# Edmondson Park Sites 1-3

## Response to DEP Comments

Fig 4.2.16

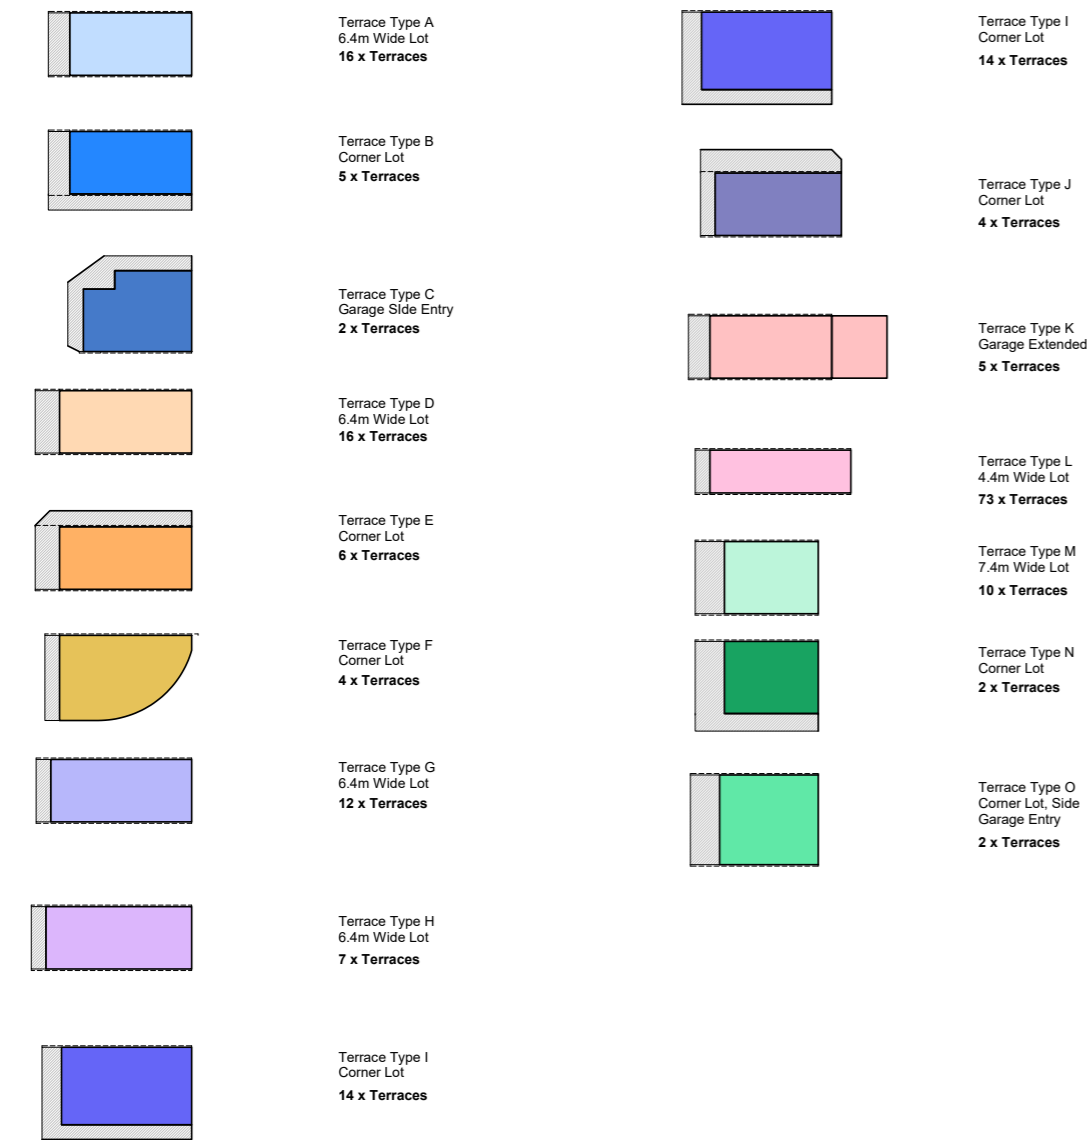
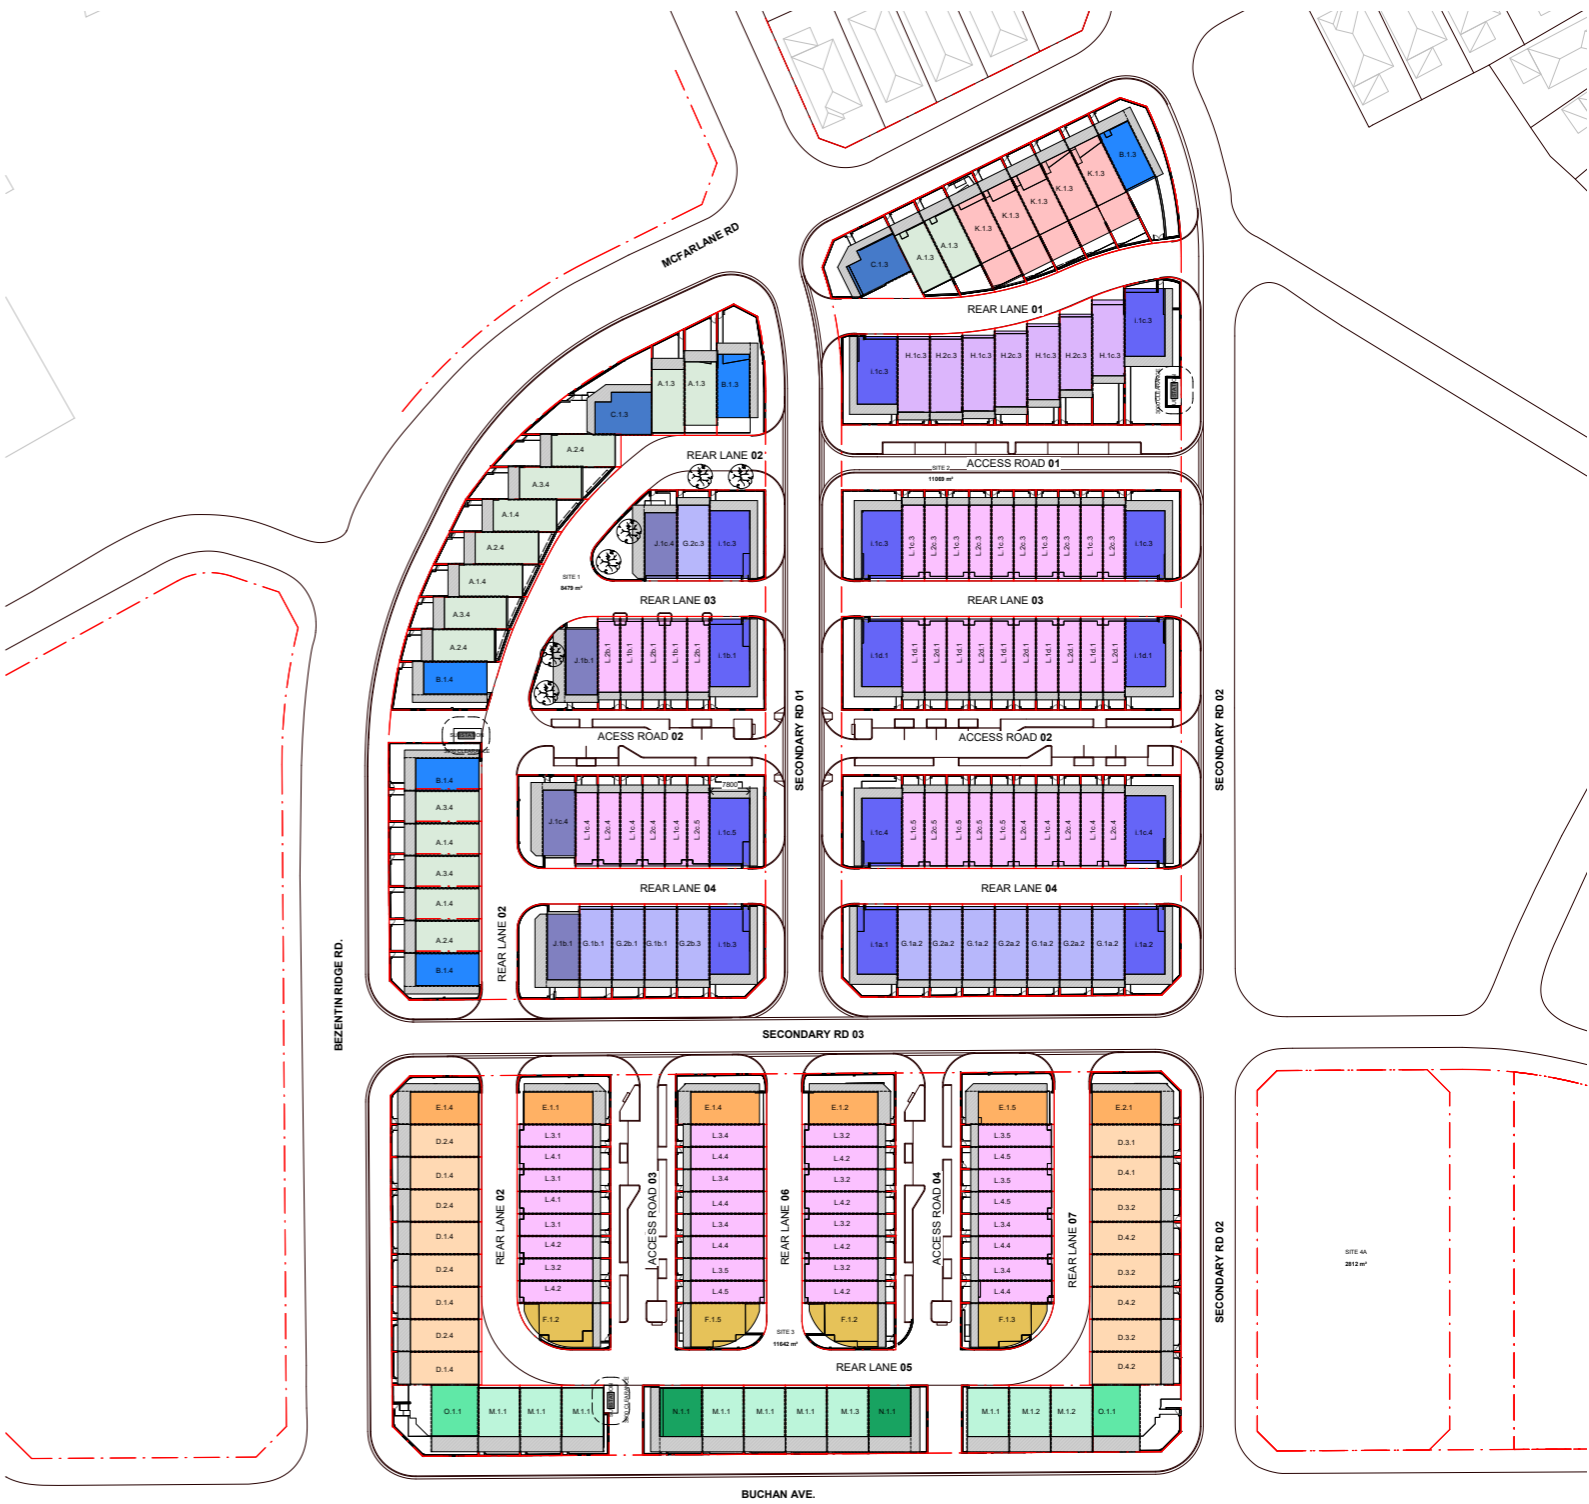
The Panel requires the applicant to ensure that the internal dimension for the terraces (i.e., clear distance between inner face of two parti-walls) are a minimum 4m wide.

The proposal consists of internal terraces spaced at 8.2m, 6.4m and 4.4m, and corner terraces generally 6.4m and wider. Taking into account a typical party wall thickness of 300mm, all terraces will have over 4m minimum dimensions.

Fig 4.5.1

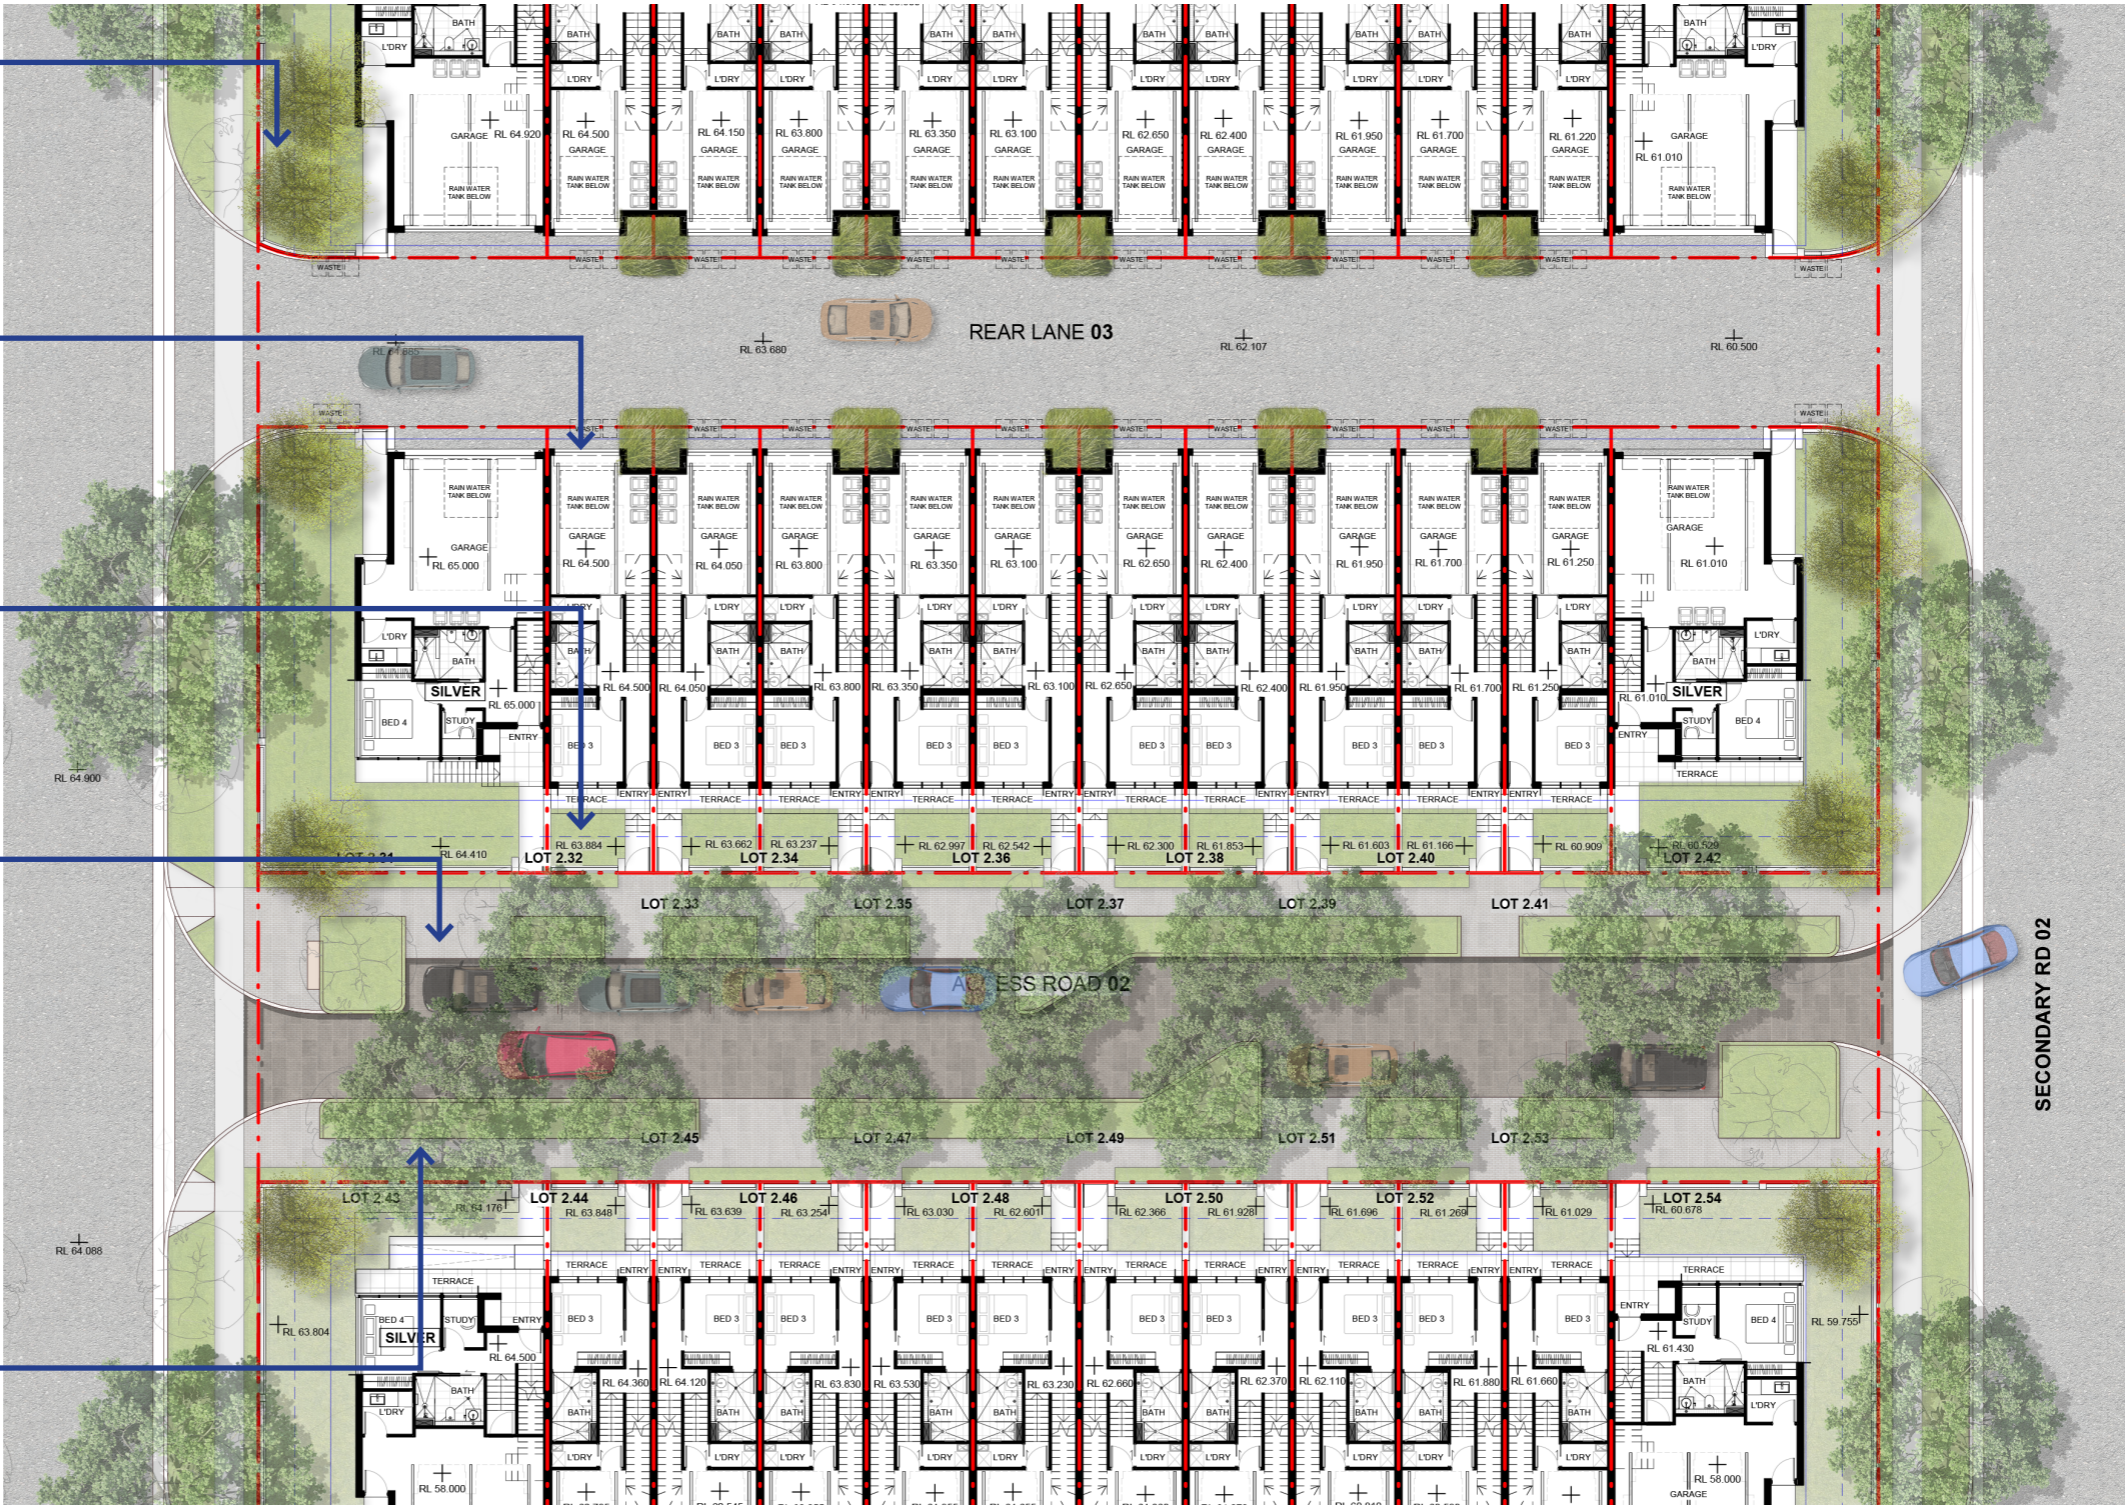
"The Panel notes that the proposed laneways are devoid of important canopy tree cover with the current configuration. The Panel recommends exploring alternative configurations such as having one -way streets to achieve more space for viable landscape / canopy tree cover opportunities.

Consider a consolidated area for bin pickup to resolve the extent of landscape works being provided within the laneways. A central collection point in a community title arrangement would be an exemplar and create an overall better impression when combined with tree planting in the lanes. Consider locating the bins along the major streets for terraces (as marked in the sketch above).

A landscaped buffer has been designed to the end of the dwellings to provide a green aspect when viewed from the secondary roads. Relocating the bin storage to these areas will dramatically reduce this greening.

Relocating the bin storage and collection to the front of the terraces will substantially take away from the landscaped and deep soil area at the front of the properties.

The current design provides for service vehicles (garbage and fire) to access the terraces via the wider rear laneways. Reducing the width of the laneways will require these vehicles to service the terraces from the access roads. These would become wider two way roads. To allow for this, the carparking spaces will need to be removed. The vegetation zones may also be impacted.

Fig 4.6.0 - 3D Image - Roof Top Terrace

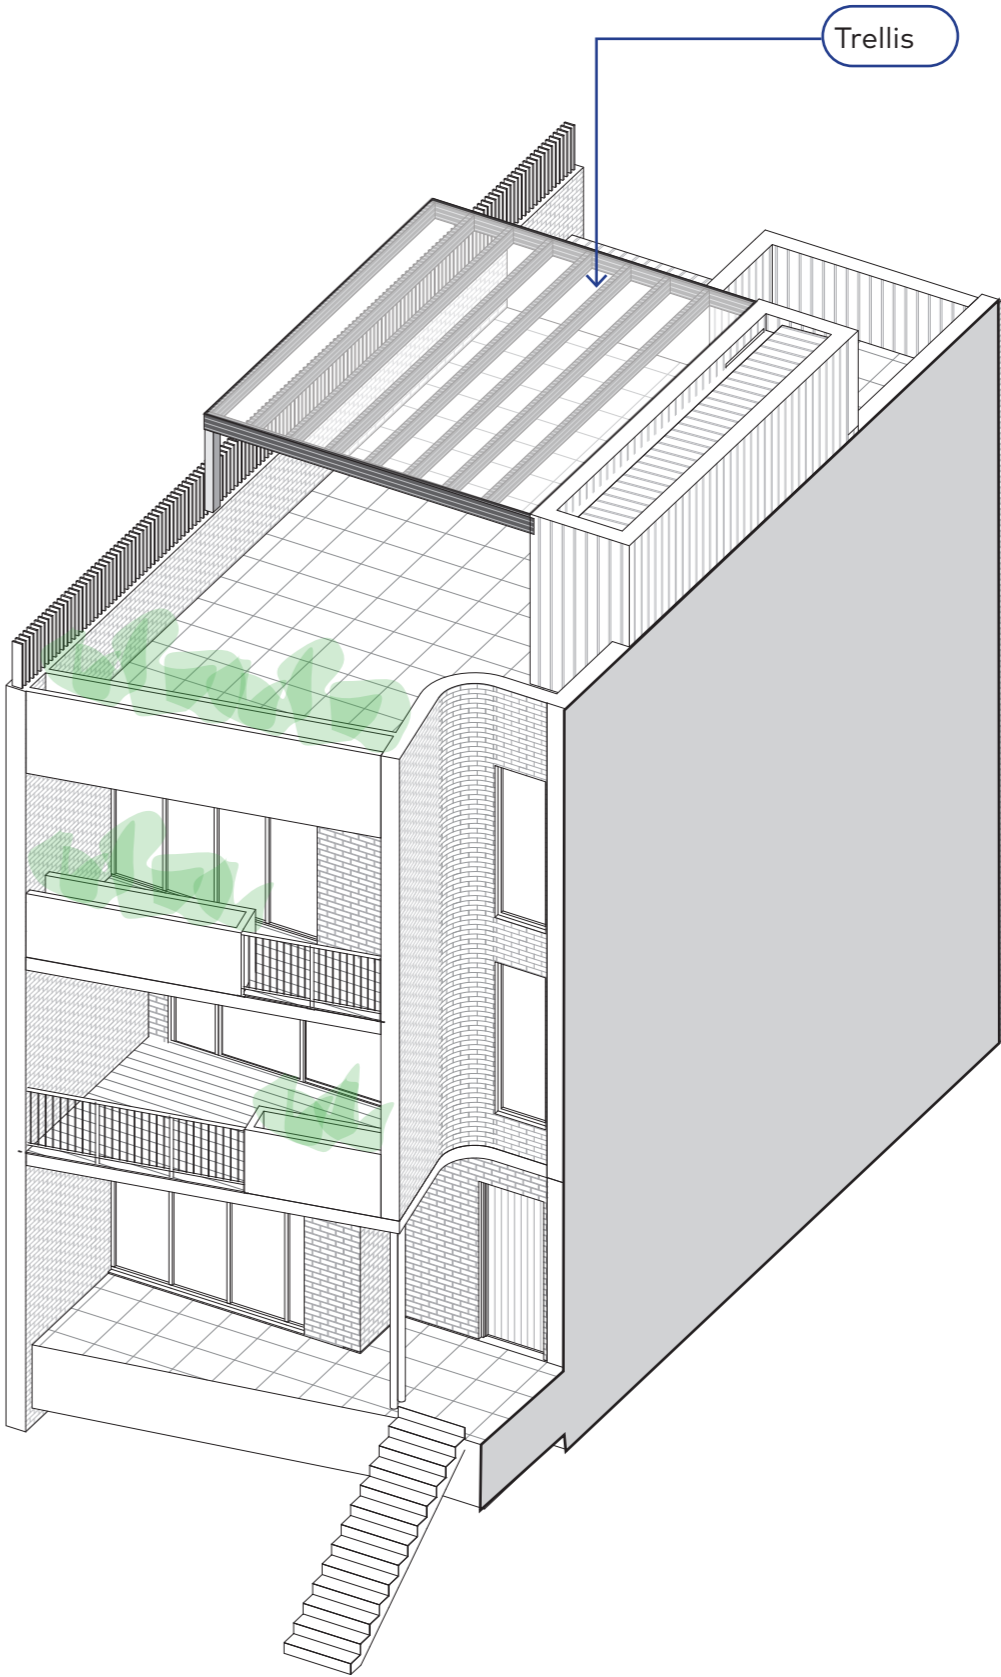
"The Panel recommends the applicant to provide adequate shade and amenity for the roof top level. Provide a pergola / trellis with seating, power points and access to water for the rooftops. The Panel recommends the applicant to provision these rooftop elements as part of a community title easement to discourage alterations in future."

Rooftop trellises are provided to the nominated terraces as part of the existing proposal. Planterboxes were previously removed in response to pre-DA DEP comments which raised concern regarding individual household maintenance and upkeep.

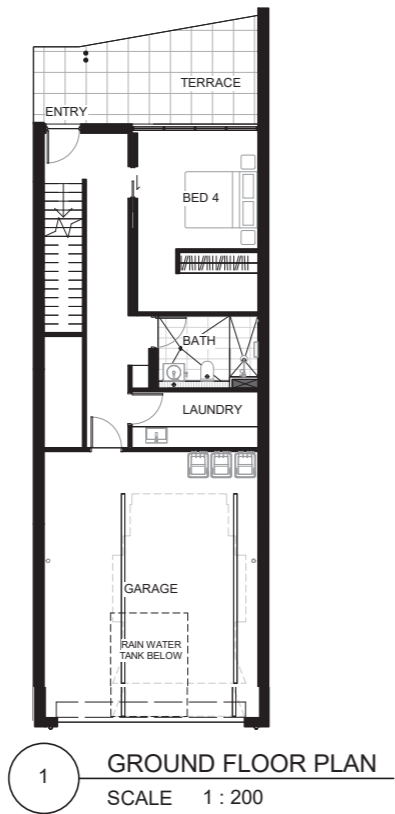
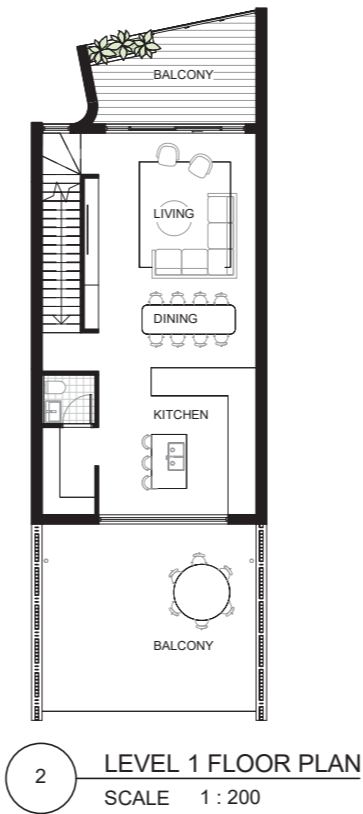
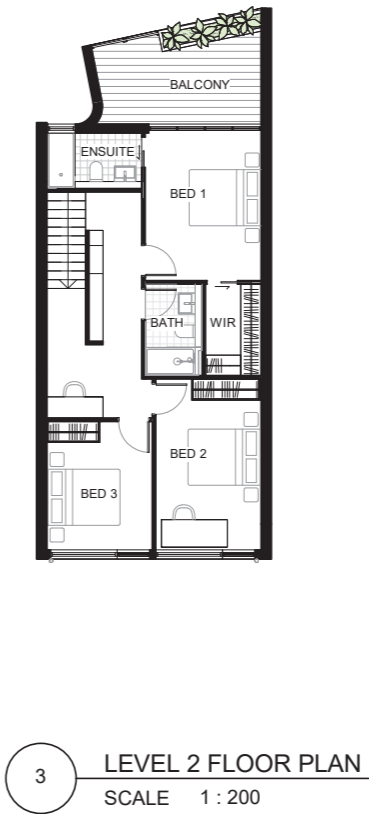
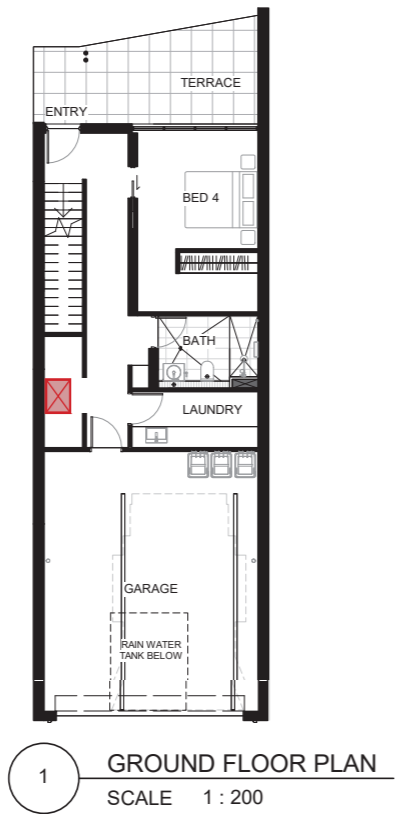
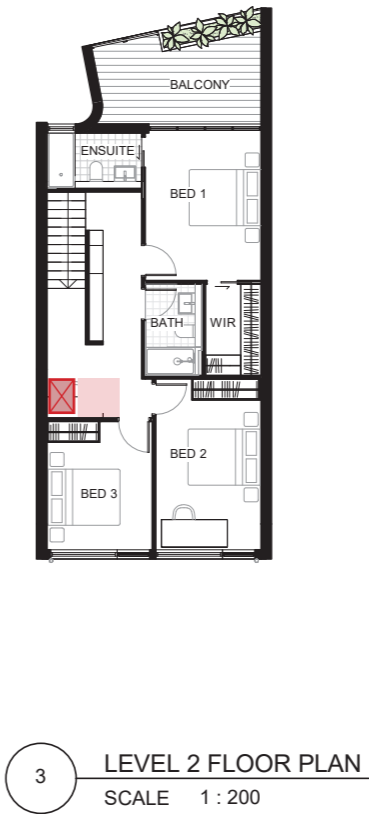
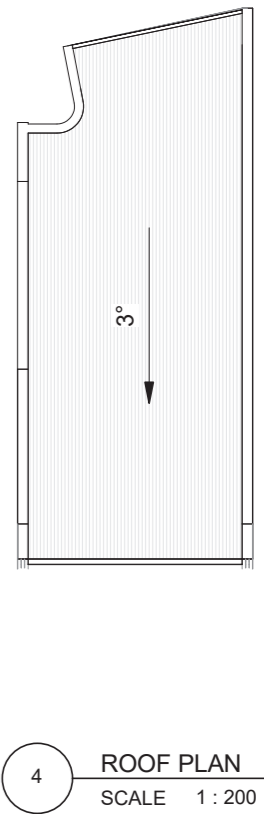
The Panel notes that there are a lot of 3-storey terrace houses which may not suit ageing people or people with restricted mobility. The Panel recommends safeguarding space for the potential inclusion of chair lifts or vertical lifts in future.

**A vertical lifting study has been conducted in response to Item 4.2 which demonstrates that the safeguarding of locations for spring lifted vertical lifting devices are able to be accommodated in particular Terrace Typologies. Vertical lifting devices are not proposed as part of this DA.**
